**MECHANICAL
INTEGRITY TEST
(MITs)**

From: Chavez, Carl J, EMNRD
Sent: Friday, October 14, 2011 7:52 AM
To: 'Moore, Darrell'
Cc: Sanchez, Daniel J., EMNRD; Dade, Randy, EMNRD
Subject: Chukka Well (API# 30-015-20894) UICI-008 WDW-2 Sept. 26, 2011 MIT

RE: Chukka WDW-2 Annulus Pressure Test (APT) Results
Subsurface Project Number: 70A6645
Test Date: September 26, 2011

WDW-2 Inspection & MIT (8/14/2009)

Ethylene glycol fluid needs to be stored on impermeable pad area

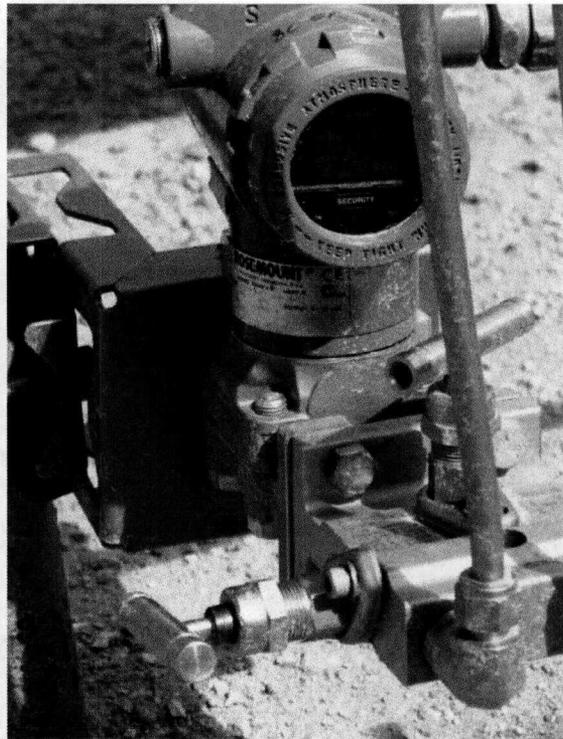
- 1) Passed standard annulus pressure MIT (Start @ 525 psig & End @ 520 psig) over 30 minutes.
- 2) Operator indicated WAMs fluid level ok (no loss or addition of ethylene glycol).
- 3) Drums containing chemicals need to be stored in impermeable pad area or removed from facility.

Chart recorder set-up w/ valve arrangement. Operator wants to replace ½ inch line with 1 inch or greater diameter size due to pressure on small line and breakage concerns during MITs.

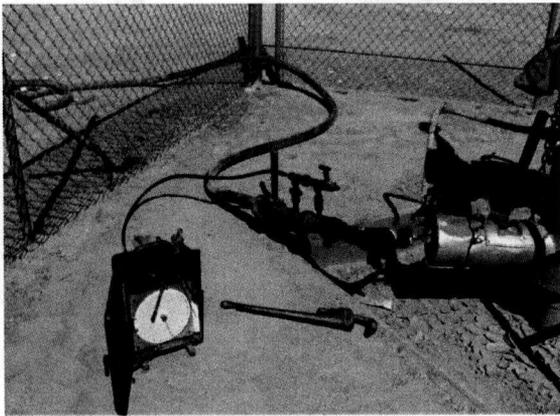
As you indicated in the field, you have placed any drums in the fenced security area into the impermeable pad area. In addition, you indicated that an RFE would be submitted to replace the ½ inch dia. piping due to the concerns about the high-pressure on a small line and over concerns of breakage on the small line during future MITs, etc.

WAMS % by DATE WDW-3

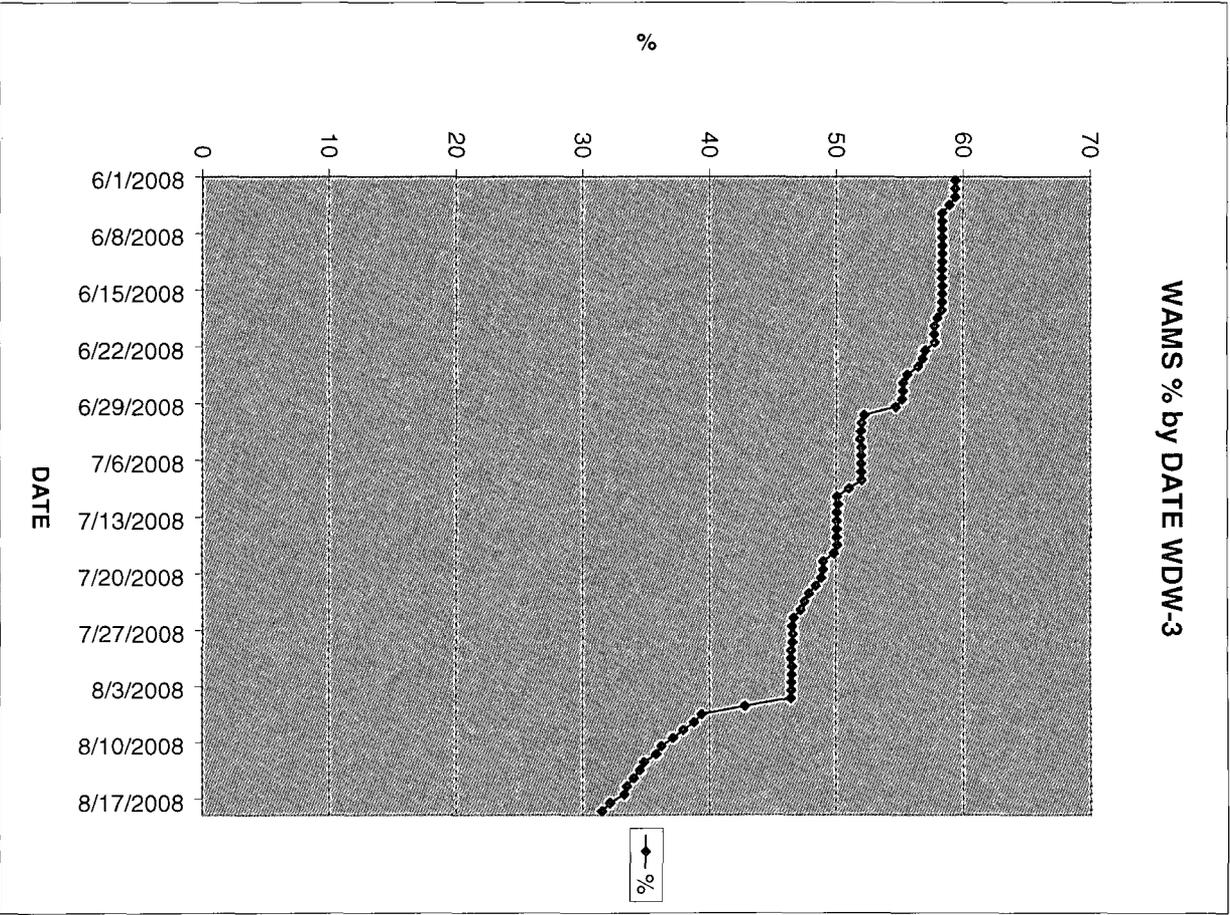
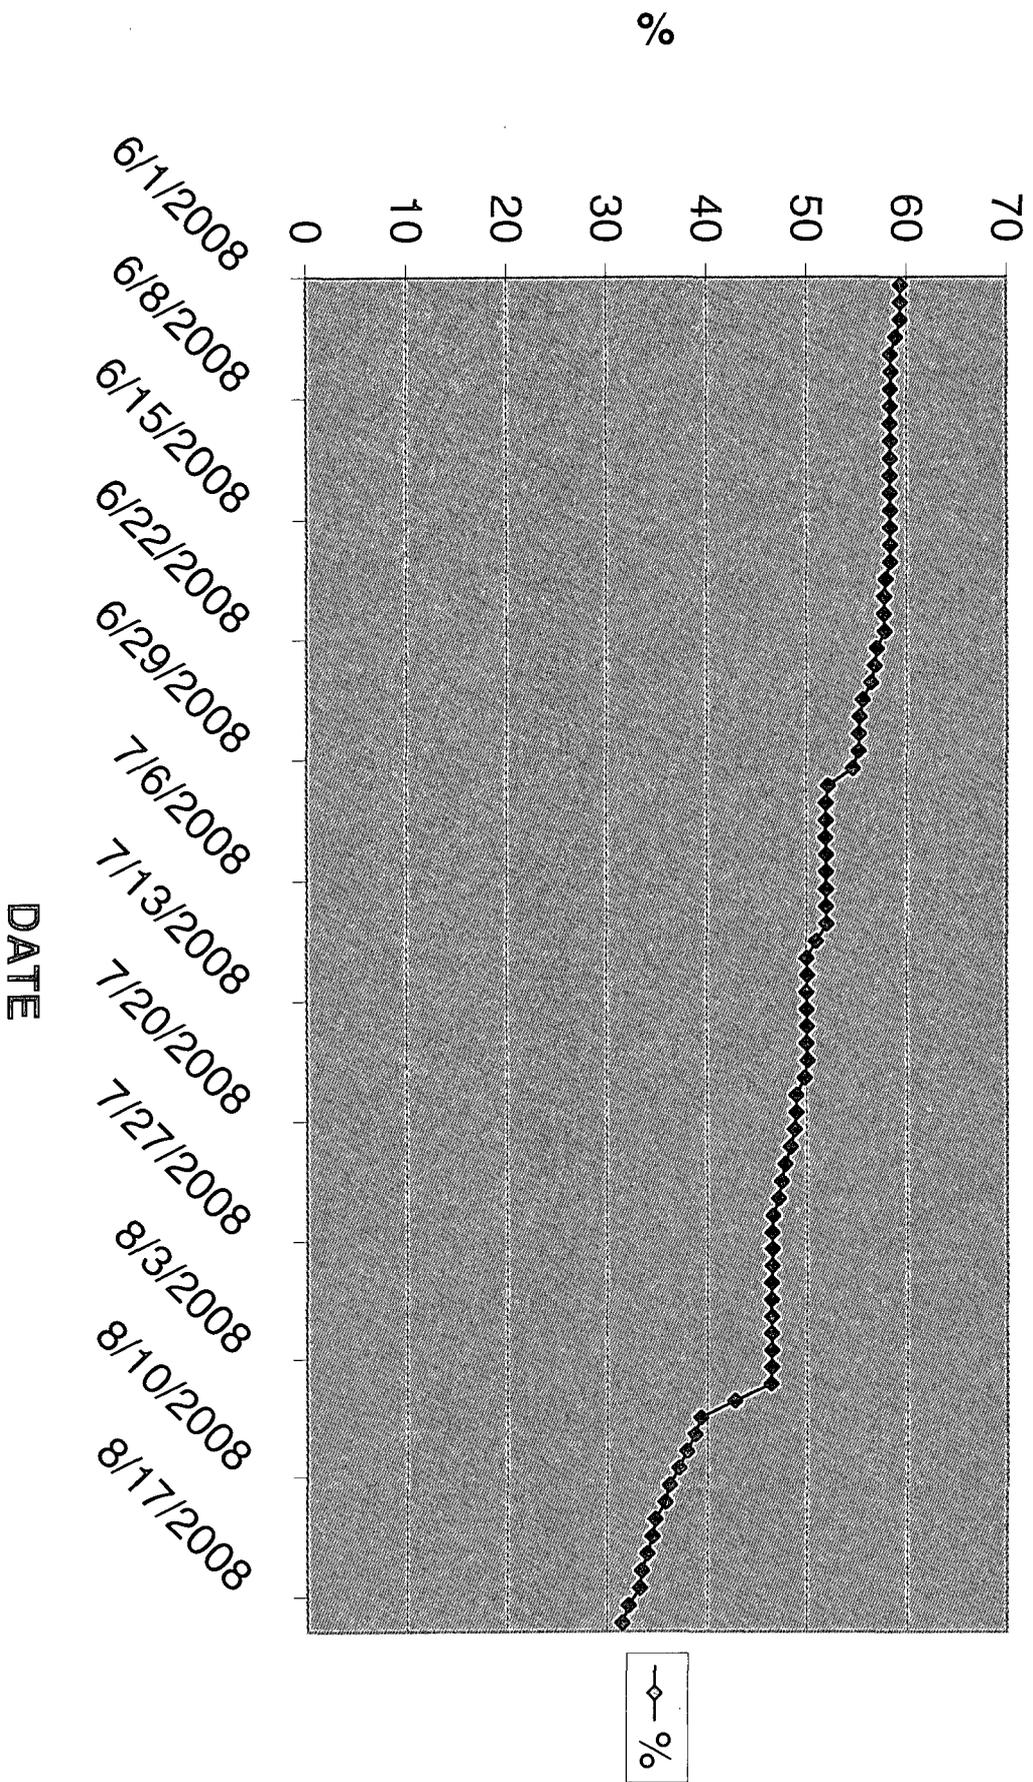
You asked for monthly information on the WAMS unit from WDW-3. Ive attached that data along with a graph. Ive included the last 2 ½ months of data. As you can see, the data shows a steady decline in the annulus fluid. As we talked about when you were here doing the MIT, we are puzzled why the WAMS shows a decline but the MIT is perfect and the pressure gauges at the well show no communication between the tubing and annulus.

I have sent the same data to our contractor, Subsurface, and they are looking into possible causes for this. I will keep you informed and update the chart every month as you requested. If there are any questions, please call me at 575-746-5281.
